Access Compliance Report

Public Rights-of-Way

(Pedestrian Signals)

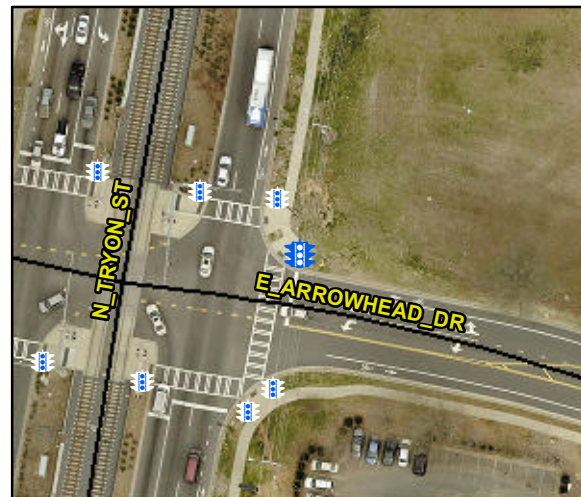
Surveyor Notes: TEXT HT 5/16

PROW/ADA: R410.6, TMUTCD 4e.08, R406.2, R209.1, MUTCD 4e.10

Possible Solutions: Replace Signal Push Button With APS Button on New Post. Remove & Replace Sign.
